DOCKETED	
Docket Number:	24-OPT-05
Project Title:	Corby Battery Energy Storage System Project
TN #:	272431
Document Title:	Michael Geller Comments - Comments on Staff Assessment Section 5-2 Biological Resources
Description:	N/A
Filer:	System
Organization:	Michael Geller
Submitter Role:	Public
Submission Date:	9/10/2026 7:12:34 AM
Docketed Date:	9/10/2026

PUBLIC COMMENTS AND LEGAL OBJECTIONS TO SECTION 5.2 — BIOLOGICAL RESOURCES

Corby Battery Energy Storage System Project WITH PHOTOGRAPHIC EVIDENCE

Figure 3. Consultant map identifying potential burrowing-owl habitat along the SID irrigation canal.

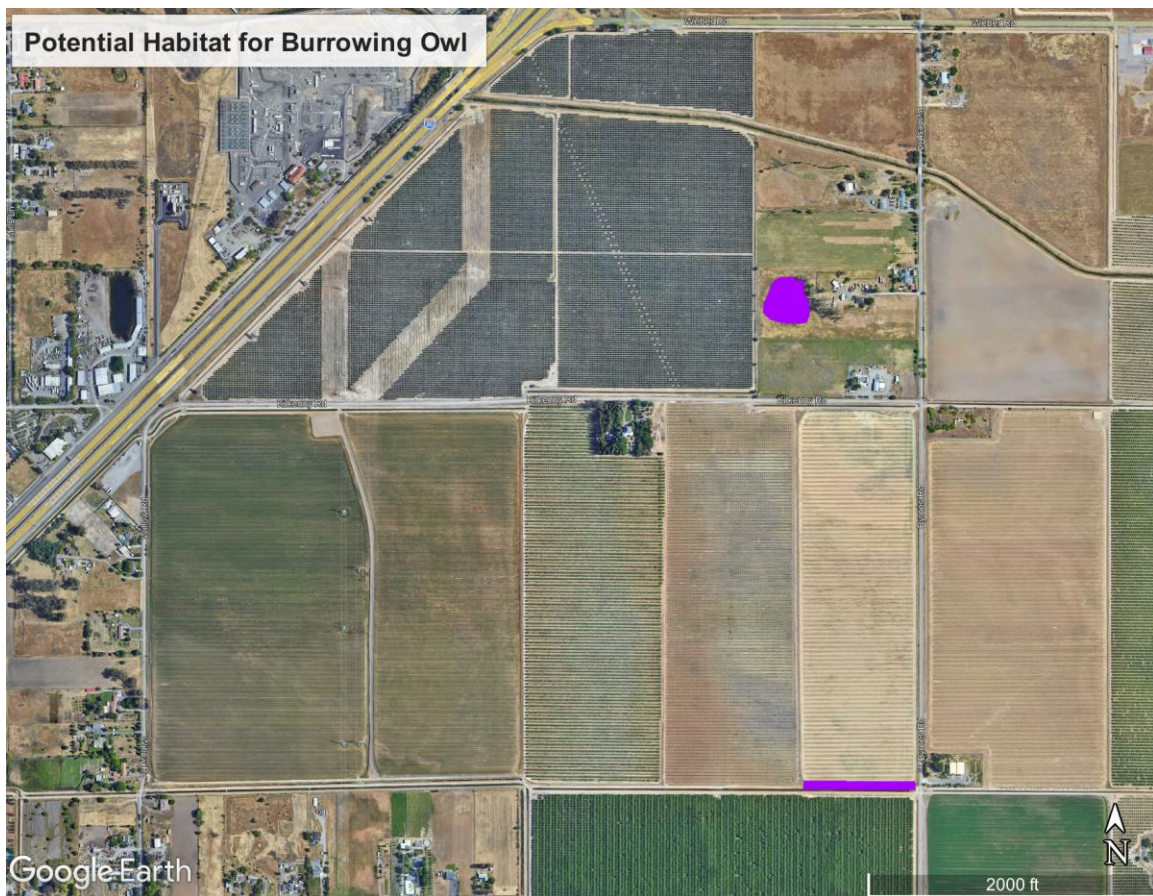
In addition, on August 7, 2026, a subsequent field investigation commissioned specifically to look for burrowing owl identified potential habitat along the SID irrigation canal. The location where the burrowing owl was photographed on January 28 and 29, 2025 is along that same SID canal, approximately 1,086 yards (0.62 mile) from the area subsequently identified as potential habitat. Although no pellets, droppings, feathers, or other evidence of current occupancy were observed during the later investigation, the photographic evidence establishes recent burrowing-owl occurrence along the same continuous physical feature where suitable habitat was independently identified.

Those facts are not contradictory. Rather, they demonstrate why a later non-detection cannot by itself establish absence from a larger habitat feature. An owl documented along the SID canal in January 2025 need not remain at the same location or leave detectable sign at another location along that canal during a subsequent inspection.

More importantly, the January 2025 photographs raise a direct question concerning Staff's conclusion that its February 2025 survey timing deviation had no effect on adequacy. The Commission should not simply accept the characterization of the protocol deviations as "minor." Staff should explain the biological basis for concluding that the deviations did not materially affect detection probability in light of documented nearby occurrences.

Requested action: Staff should reevaluate the burrowing-owl baseline using the January 2025 photographic evidence and mapped potential habitat; conduct or require fully protocol-compliant surveys during the appropriate survey periods; and revise the impact analysis and mitigation if those surveys establish occupancy or regular use.

Figure 4. Two monarch butterflies photographed mating on July 20, 2026, at a residence in the immediate vicinity of the Corby BESS Project.

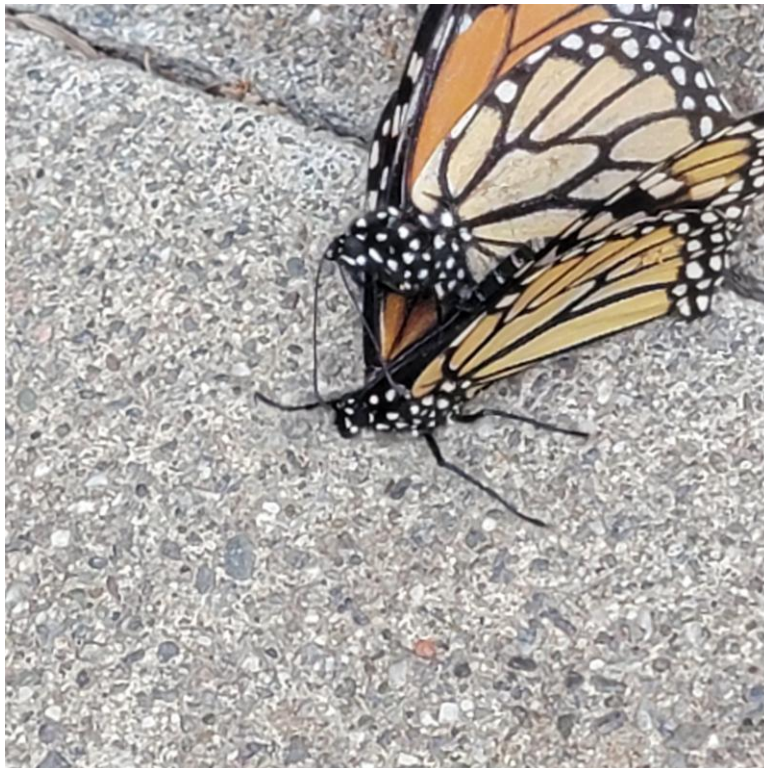
On July 20, 2026, two monarch butterflies were photographed mating at a residence in the immediate Corby project vicinity.

The photograph does not establish that monarchs breed on the Corby site itself, nor does it establish that milkweed occurs on the project footprint. These comments do not make either claim.

It does establish something considerably narrower but important: monarch butterflies are currently present in the immediate project vicinity and were observed engaging in reproductive behavior.

That evidence should be considered when Staff evaluates its survey results and its characterization of monarch occurrence potential. The proper response is not to claim that one photograph proves a significant Project impact. The proper response is to ensure that the Commission's biological baseline reflects actual, recent observations rather than treating failure to detect a species during earlier surveys as proof of absence.

Requested action: Add the July 20, 2026 monarch observation to the biological record and determine whether the observation warrants supplemental host-plant or monarch surveys before finalizing the significance determination.
